Virgil C. Summer Nuclear Station (VCSNS) Units 2 & 3
Combined License Nos. NPF-93 and NPF-94
Docket Nos. 52-027 and 52-028

Subject: LAR 13-07, License Amendment Request and Exemption: Changes to the Chemical and Volume Control System (CVS)

Enclosure 1: Virgil C. Summer Nuclear Station Units 2 & 3 – Request for License Amendment Regarding Changes to the Chemical and Volume Control System (CVS) (LAR 13-07)

**Proposed Changes to Licensing Basis Documents
(LAR 13-07)**

Tier 1 Figure 2.2.1-1
Containment System
See next page

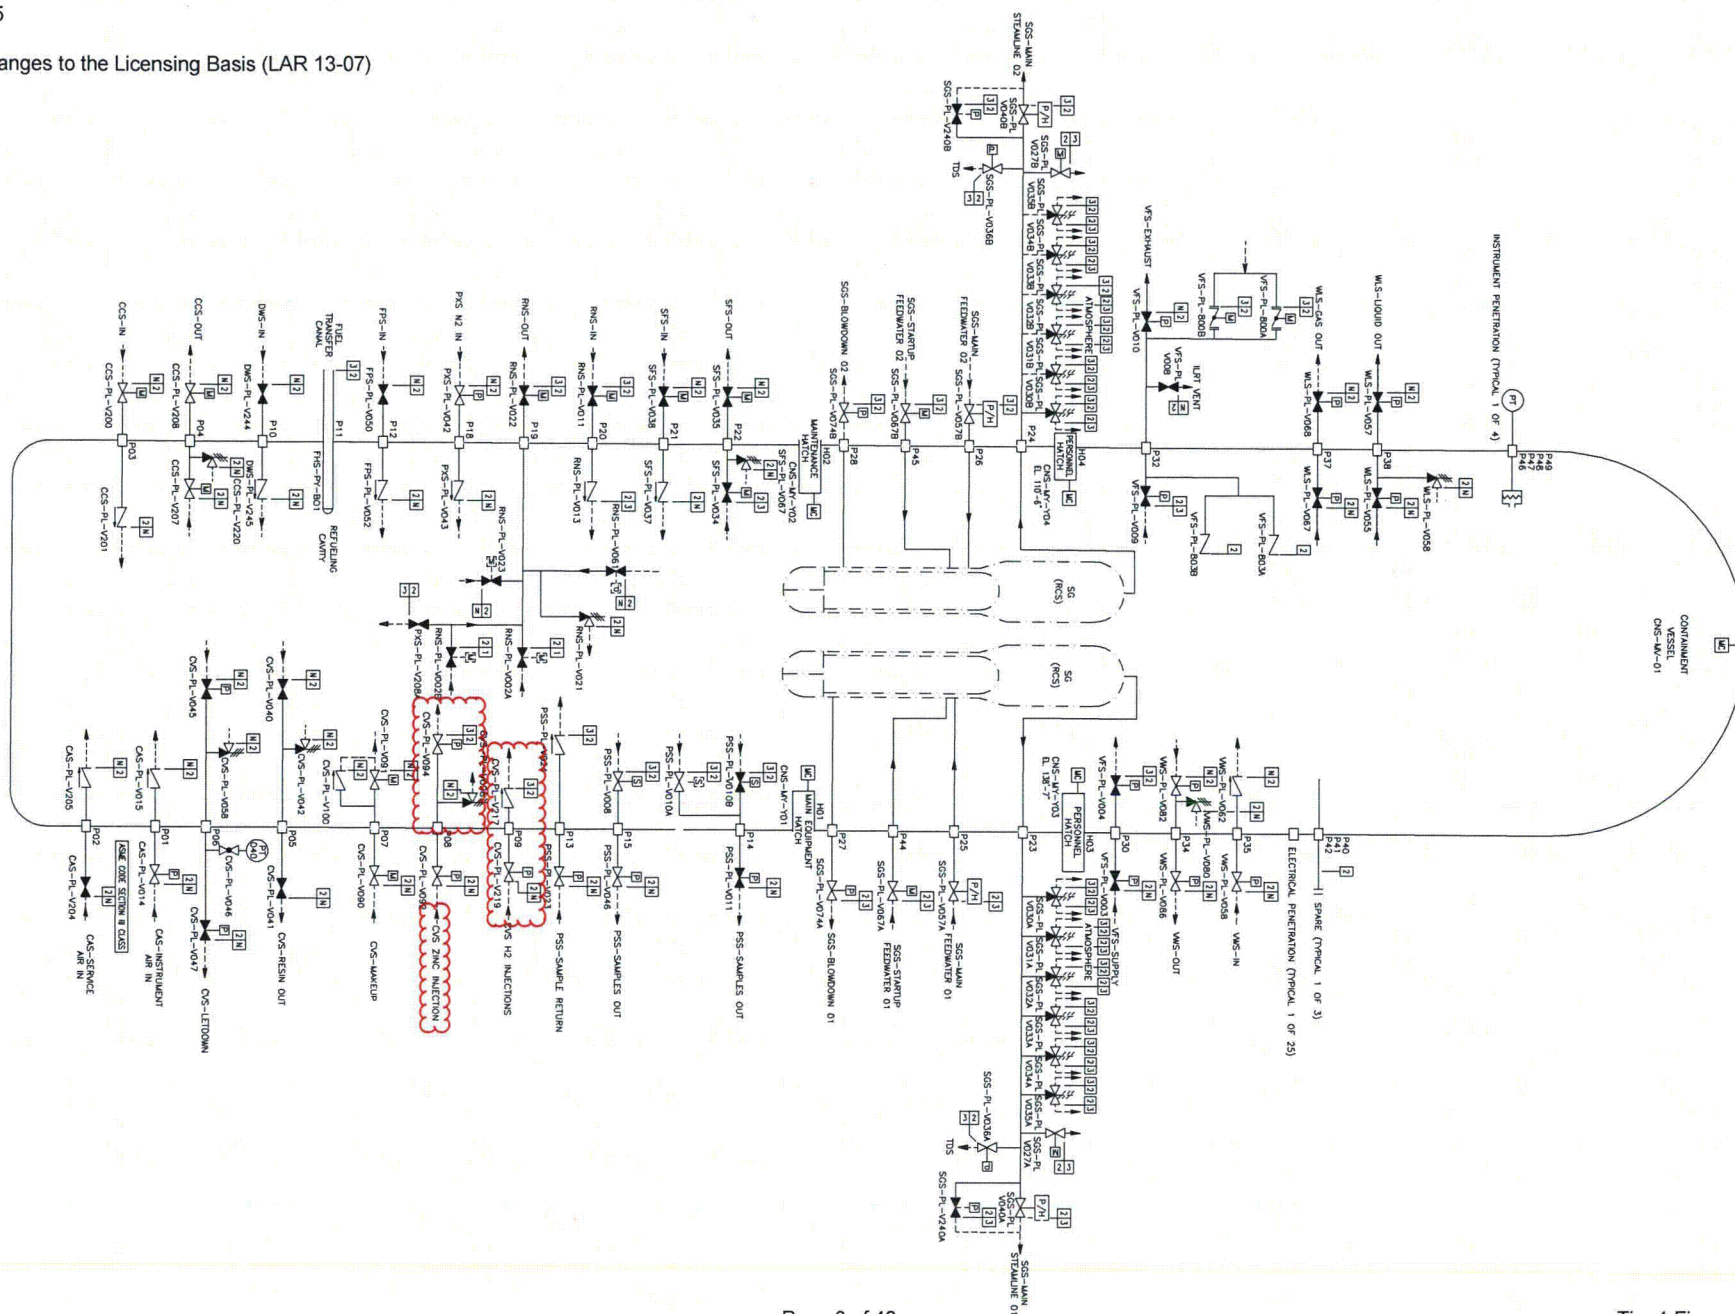
<u>Plant-Specific Changes</u>	<u>Description of Proposed Change</u>
Tier 1 and COL App. C Figure 2.2.1-1	Revise CVS-PL-V094 inboard containment isolation lift check valve type to AOV and add CVS-PL-V098 pressure relief valve ²
Tier 1 and COL App. C Table 2.3.2-1	Revise CVS-PL-V094 AOV requirements/title and add CVS-PL-V098 pressure relief valve, and requirements
Tier 1 and COL App. C Figure 2.3.2-1	Revise CVS-PL-V094 inboard containment isolation valve type from a lift check valve to an AOV and add CVS-PL-V098 pressure relief valve
UFSAR Table 3.2-3	Add CVS-PL-V098 and requirements
UFSAR Table 3.9-12	Add CVS-PL-V098 and requirements
UFSAR Table 3.9-16	Revise CVS-PL-V094 from check valve to AO globe valve and revise the requirements from those applicable to a lift check valve to those applicable to an AOV (including changing Safety Functions from 'Active' to 'Active-to-Failed'), and add CVS-PL-V098 and requirements, including "Thermal Relief" under "Valve/Actuator Type" column

<u>Plant-Specific Change</u>	<u>Description of Proposed Change</u>
Tier 1 and COL App. C Figure 2.2.1-1	Rename the function of CNS containment penetration P08 from 'CVS - H2 Injections' to 'CVS - Zinc Injection,' and add CNS containment penetration P09 for CVS H2 Injection, with check valve CVS-PL-V217 inside containment and globe valve CVS-PL-V219 outside containment
Tier 1 and COL App. C Figure 2.3.2-1	Rename (from "H2 Addition" to "Zinc Addition") the input to CVS-PL-V092 and CVS-PL-V094, and connect the output from CVS-PL-V094 to the shell side inlet line of the Regenerative Heat Exchanger (RHX). Add new hydrogen "H2 Addition" through globe valve CVS-PL-V219, then the containment penetration, then check valve CVS-PL-V217, and then connect to the RHX shell side output between CVS-PL-V080 and CVS-PL-V084, which is the same injection point of the previous zinc/hydrogen injection line
Tier 1 and COL App. C Table 2.3.2-1	Change CVS-PL-V092 from 'Hydrogen Addition Line Containment Isolation Valve' to 'Zinc Injection Containment Isolation Valve ORC' Change CVS-PL-V094 from 'Hydrogen Addition Line Containment Isolation Check Valve' to 'Zinc Injection Containment Isolation Valve IRC'

- Figure 2.2.1-1, Containment System (CNS),
 - Rename the function of CNS containment penetration P08 from 'CVS - H2 Injection' to 'CVS - Zinc Injection,' and add CNS containment penetration P09 for CVS H2 Injection, with check valve CVS-PL-V217 inside containment and globe valve CVS-PL-V219 outside containment

- Revise CVS-PL-V094 inboard containment isolation lift check valve type to AOV and add CVS-PL-V098 pressure relief valve
- Table 2.3.2-1
 - Add CVS-PL-V067 'Makeup Return Line Bypass Check Valve', and requirements

Tier 1 Figure 2.3.2-1
Chemical and Volume Control System
See next page

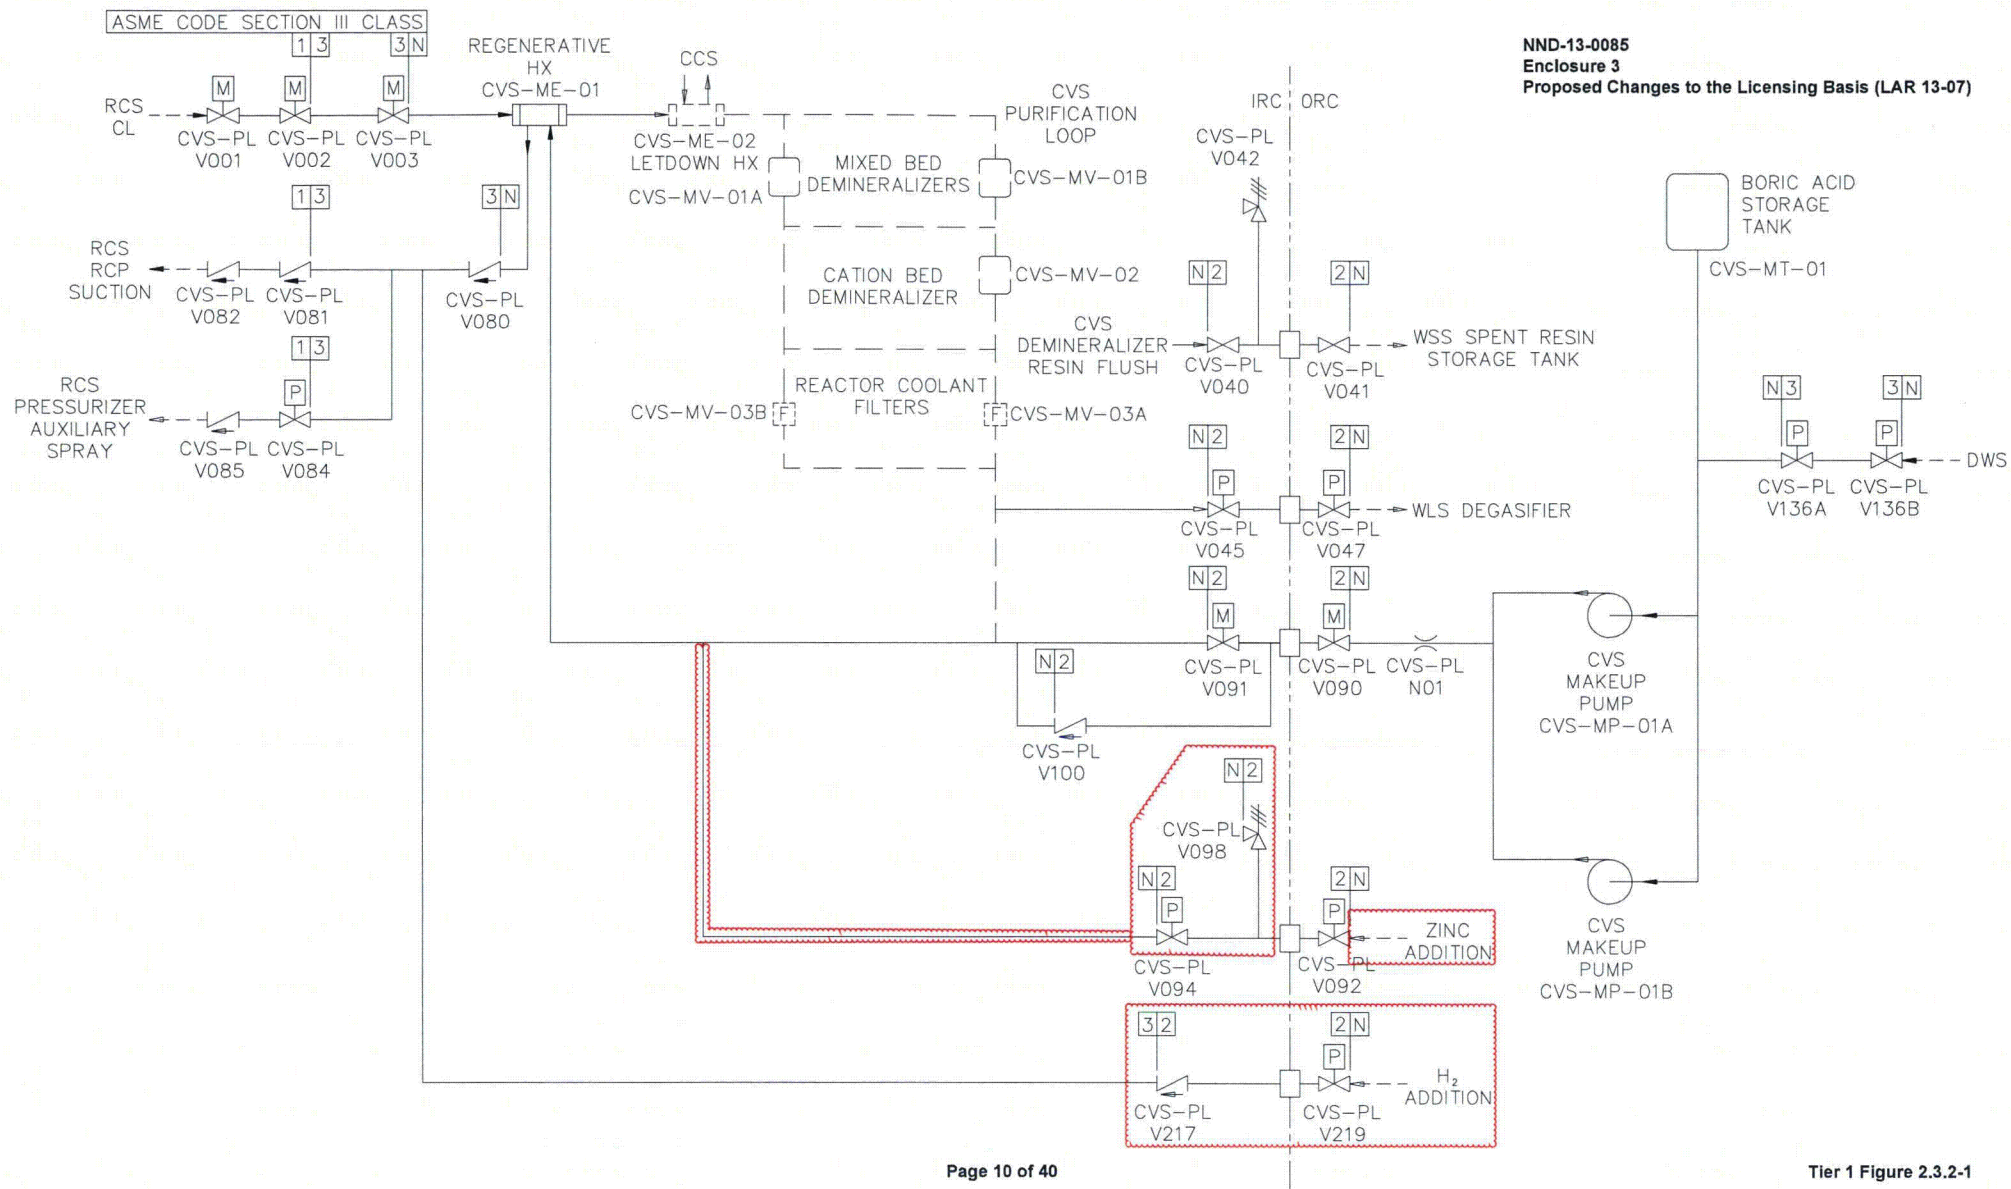
- Figure 2.3.2-1
 - Rename (from "H2 Addition" to "Zinc Addition") the input to CVS-PL-V092 and CVS-PL-V094, and connect the output from CVS-PL-V094 to the shell side inlet line of the Regenerative Heat Exchanger (RHX)

- Add new hydrogen addition injection through globe valve CVS-PL-V219, then the containment penetration, then check valve CVS-PL-V217, and then connect to the RHX shell side output between CVS-PL-V080 and CVS-PL-V084

UFSAR Figure 9.3.6-1 (Sheet 1 of 2)
Simplified Chemical and Volume Control
System Piping and Instrumentation
(REF) CVS 001
See next Page

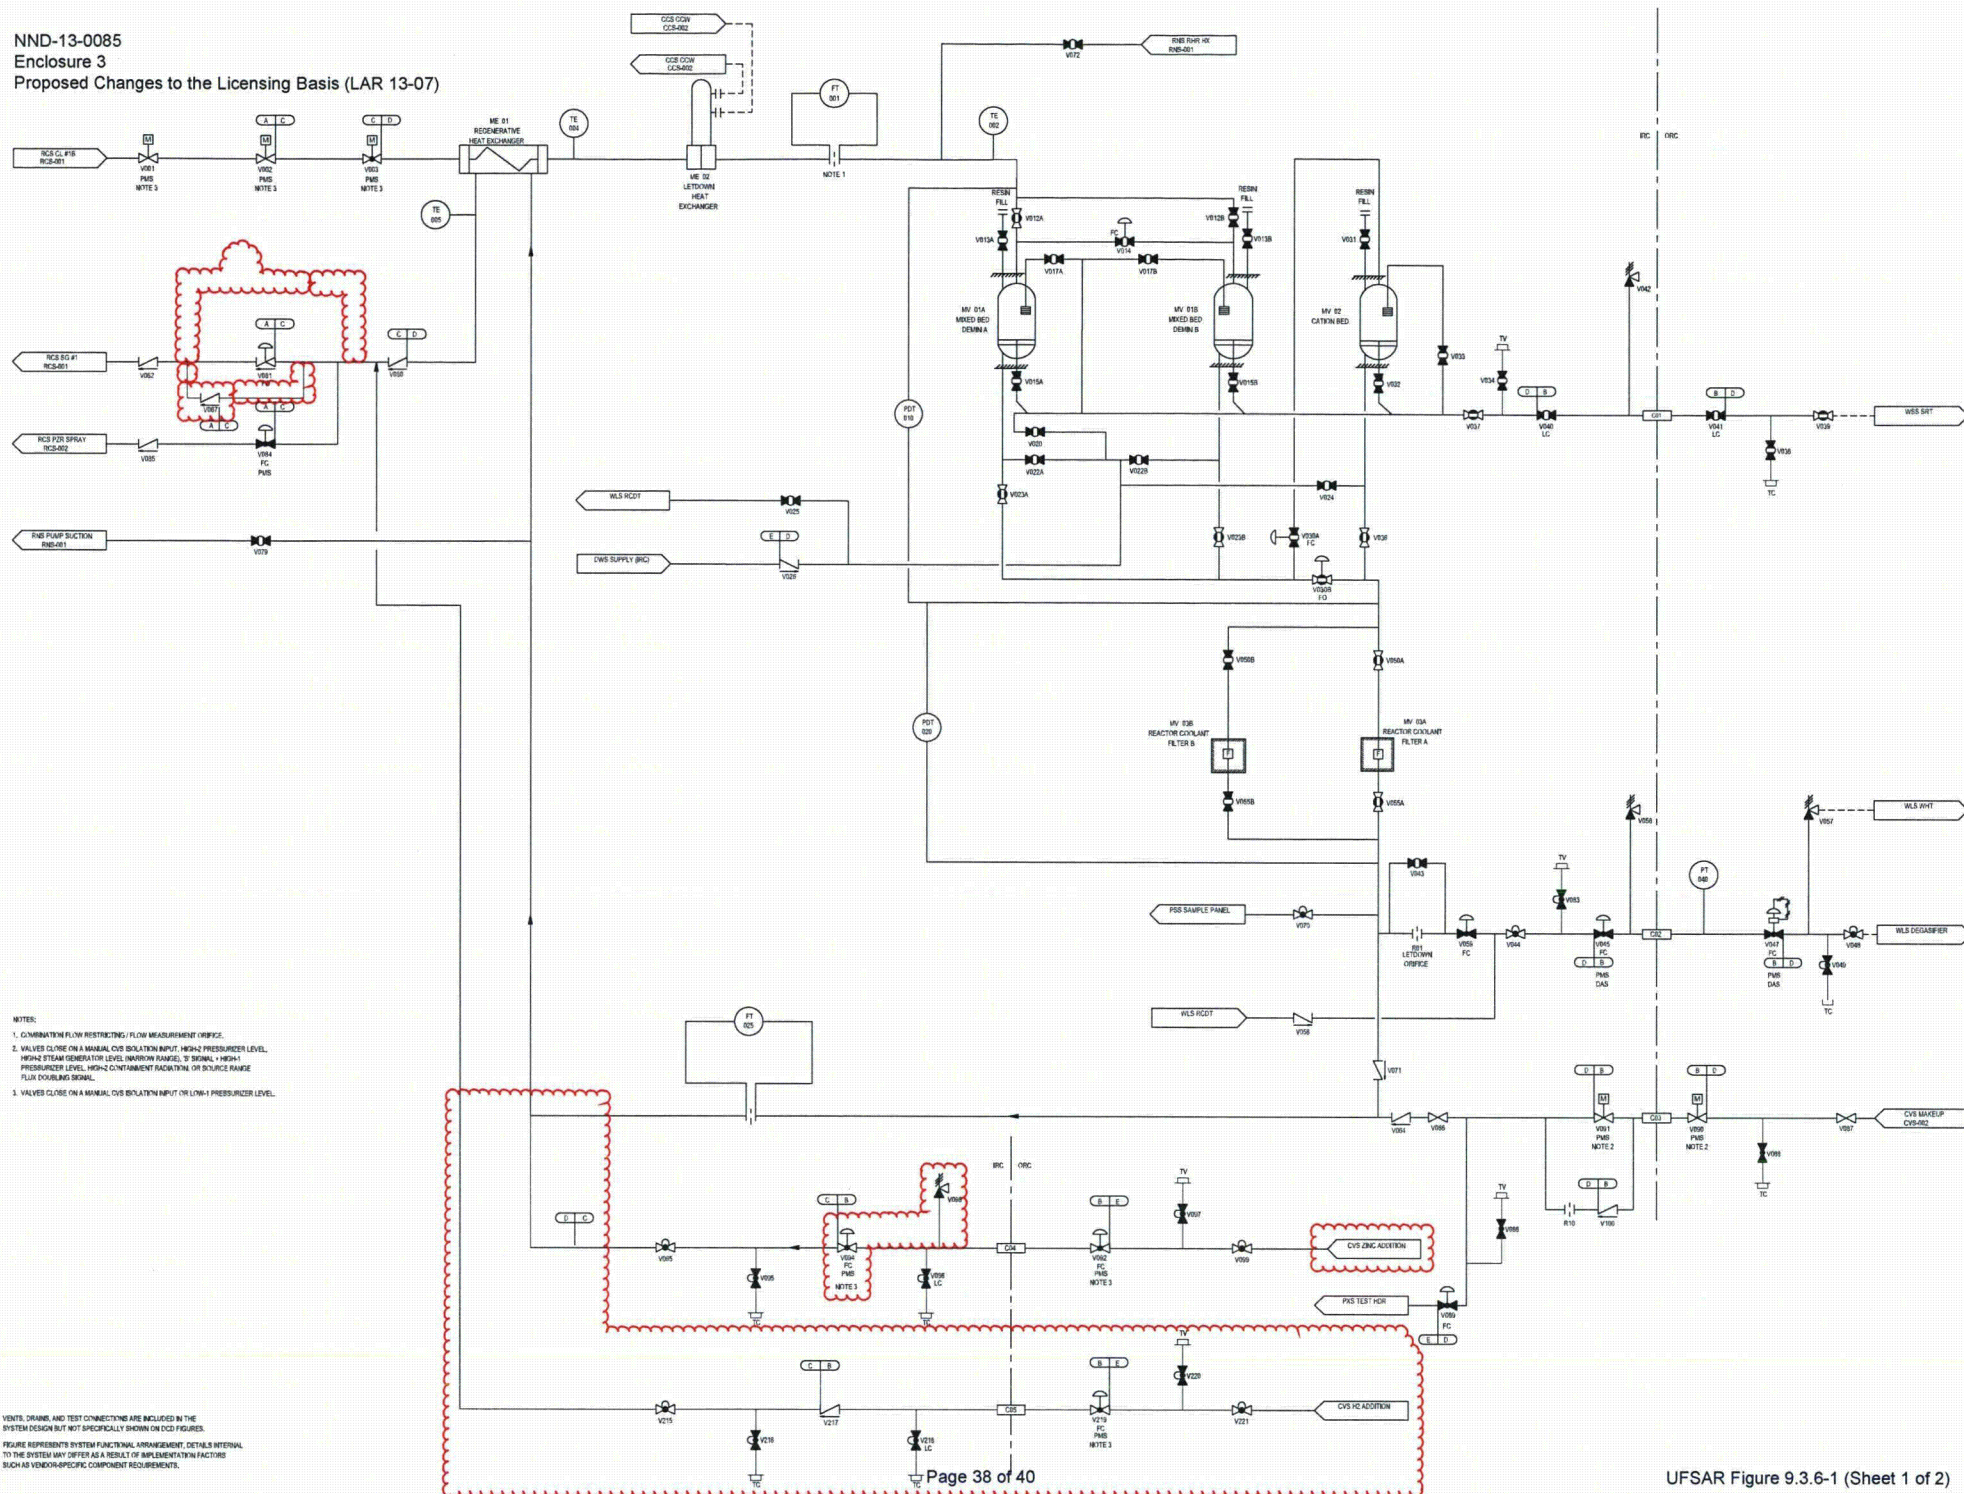
<u>Plant-Specific Changes</u>	<u>Description of Proposed Change</u>
UFSAR Figure 9.3.6-1	Delete valves CVS-PL-V068 and CVS-PL-V069, add valve CVS-PL-V067 to the bypass line off the main process line originating at a point downstream of the connection to the Auxiliary Pressurizer Spray Line Isolation Valve (CVS-PL-V084) and upstream of valve CVS-PL-V081.

UFSAR Figure 9.3.6-1	<p>Rename (from "H2/Zinc Add" to "Zinc Addition") the input to CVS-PL-V092 and CVS-PL-V094, and connecting the output from CVS-PL-V094 to the shell side inlet line of the Regenerative Heat Exchanger (RHX); add new hydrogen "H2 Addition" through new CVS-PL-V219, then the new containment penetration CVS-PY-C05, then new CVS-PL-V217, and then connecting to the RHX shell side output between CVS-PL-V080 and CVS-PL-V084, which is the same injection point of the previous zinc/hydrogen injection line</p>
